SURRY POWER STATION, UNIT NO. 2

AMENDMENT TO FACILITY OPERATING LICENSE

Amendment No. 45
License No. DPR-37

ATTACHMENT TO LICENSE AMENDMENTS

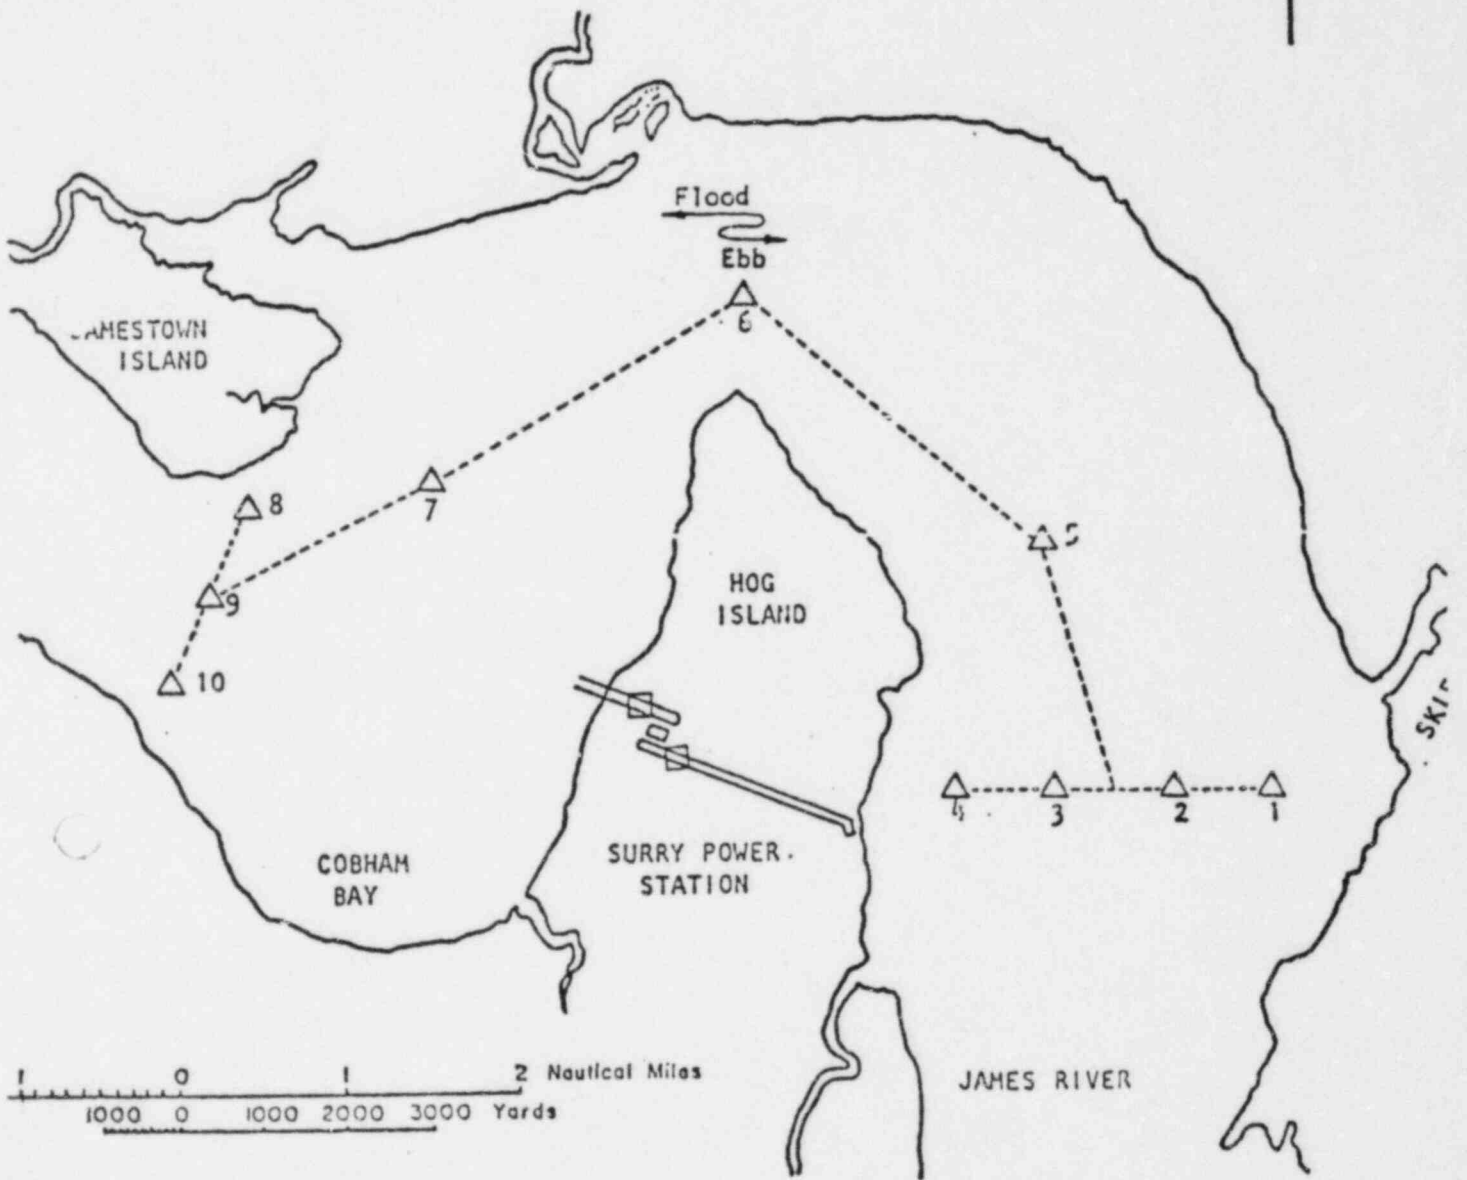
1. The monitoring program shall encompass the segment of the James River Estuary which extends from below the intake of the Surry Power Station upstream to the southern shore of Jamestown Island as shown on TS Figure 4.13-1.

2. The horizontal and vertical temperature-salinity structure of the tidal segment shall be determined at monthly intervals as follows: Cruises shall be conducted at slack before flood tide. A four (4) station transect shall be established between the intake structure and Skiffes Creek just before low slack water. Temperature and salinity data shall be collected at two (2) meter intervals from surface to bottom. The cruise shall continue up the channel with same slack stations established at approximately two (2) mile intervals in the middle of the river. The final transect shall be made between Jamestown Island and Crouches Creek.

SURRY
POWER STATION

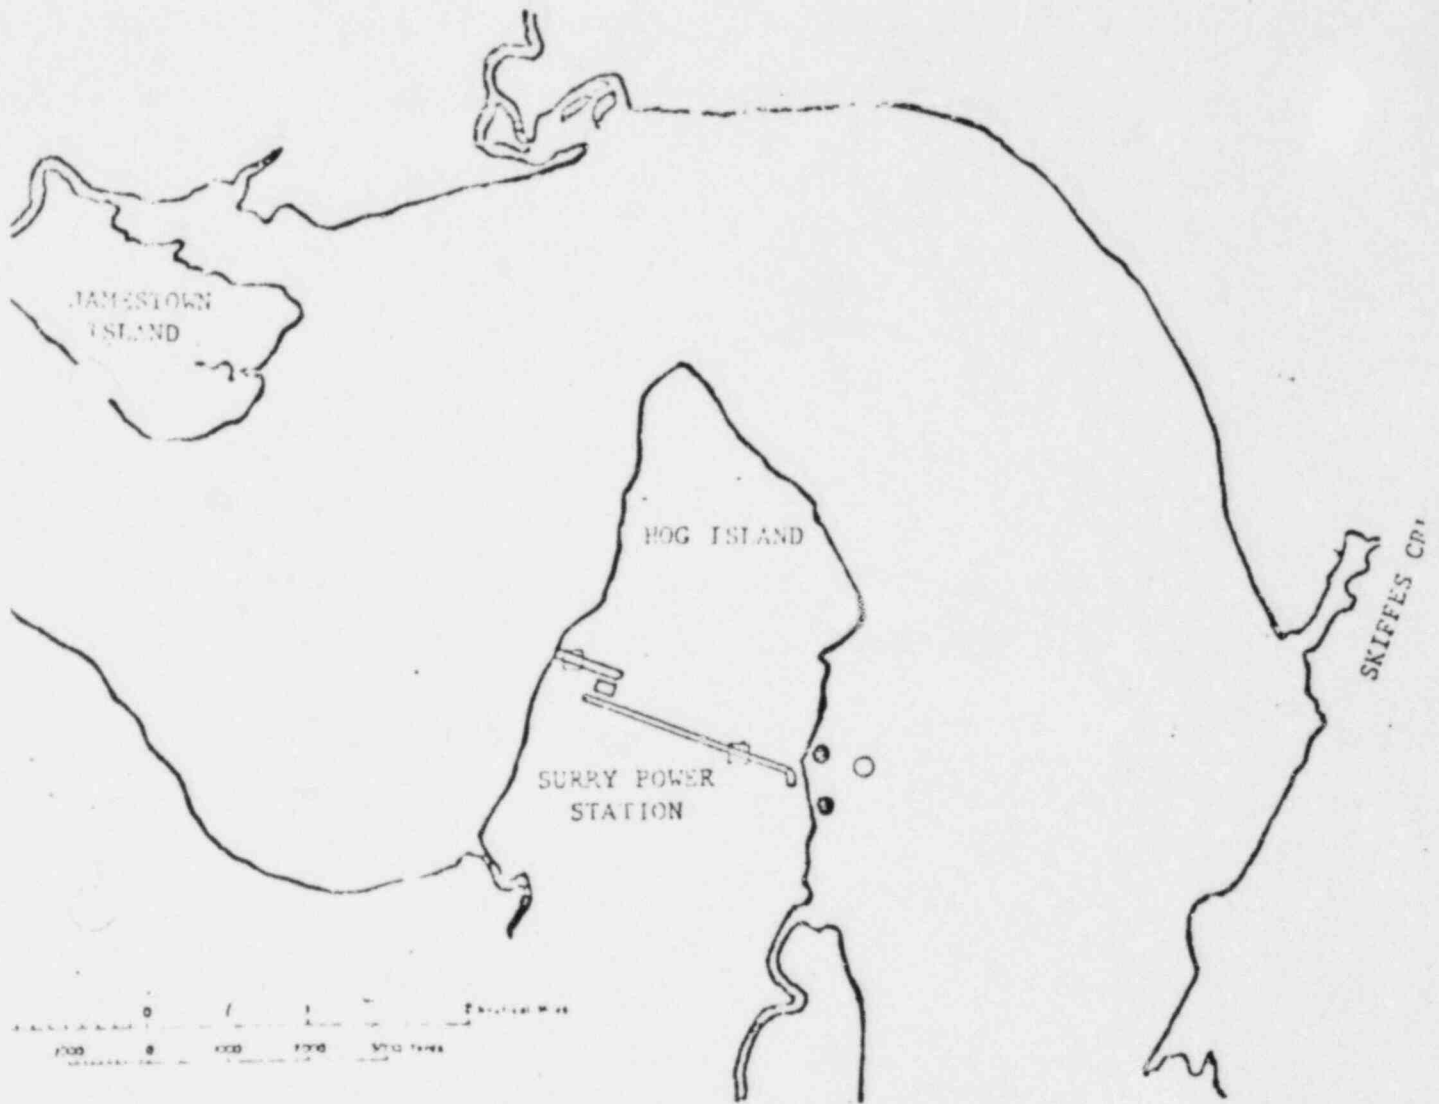
B. A fish sampling program in the vicinity of the intake structure shall be conducted. Monthly trawls and seine hauls will be taken at stations identified in TS Figure 4.13-2. Concurrent temperature and salinity measurements shall be made with the trawls and seine hauls.
